Response to Reviewers — SENSL-26-06-RL-0906

“Wire-Level Interrupt-to-Decision Latency of On-Sensor MLC versus Host Inference on the NVIDIA Jetson Orin Nano: A Pre-Registered Measurement Study”

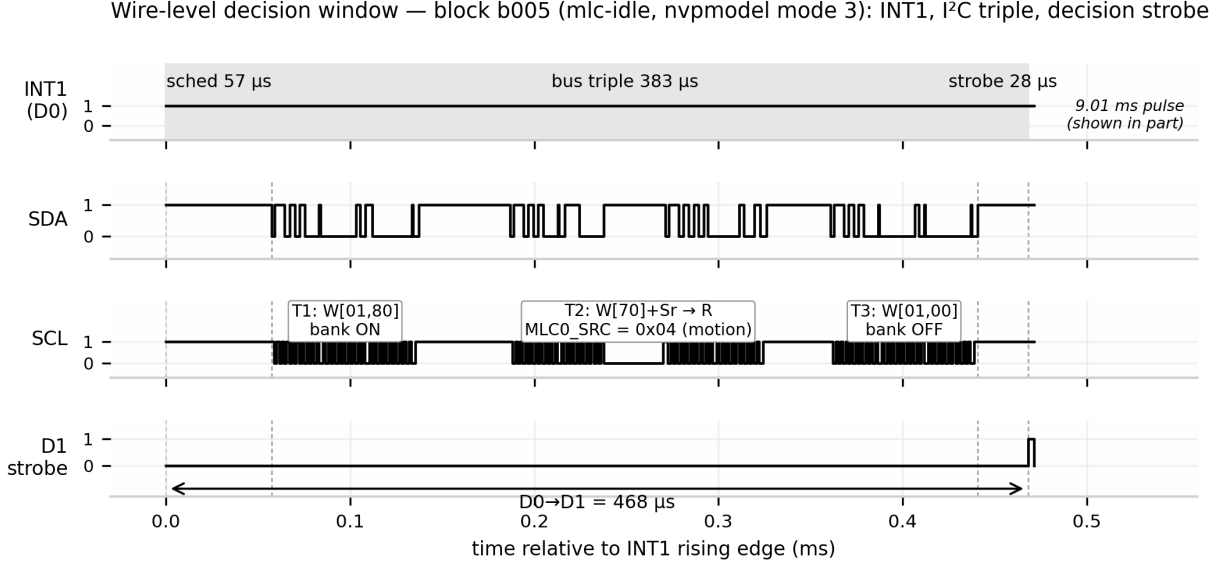
“For a ‘wire-level’ study, the absence of logic-analyzer traces, or a timing diagram showing INT1/D1 edges and the three I²C transactions, is a glaring omission. A single figure would have added enormous credibility.”

Response: We agree, and the omission is corrected with a measured SDA/SCL figure, not a schematic. The figure below is rendered by `code/analysis/fig_wire_timing.py` directly from the archived Saleae export for block b005 (mlc-idle, nvpmode mode 3) in the evidence package (Zenodo DOI 10.5281/zenodo.22950121). The four lanes are INT1 (D0), SDA, SCL, and the decision strobe D1. The decoder requires and finds exactly the four wire frames of the bank-switch read in the shown window: T1 W[01,80] (embedded-functions bank ON), T2 W[70] + repeated-start read of MLC0_SRC (=0x04, motion), and T3 W[01,00] (bank OFF). For the shown window (t = 22.906 s): INT1→first-byte scheduling 57.4 μs, complete three-transaction triple 383.4 μs, last-STOP→D1 strobe 27.5 μs, D0→D1 468.3 μs, with no foreign frame inside the triple. Campaign statistics remain in Table I and S4; this figure is the wire-level existence proof for the protocol those statistics decompose.

Manuscript changes: §VI.A pointer sentence added; the measured capture is provided as Fig. S4 in the supplementary material and is embedded in this response, generated reproducibly by `code/analysis/fig_wire_timing.py` from the archived capture; the extended candidate-mechanism discussion remains in S3 to preserve the 4-page limit.
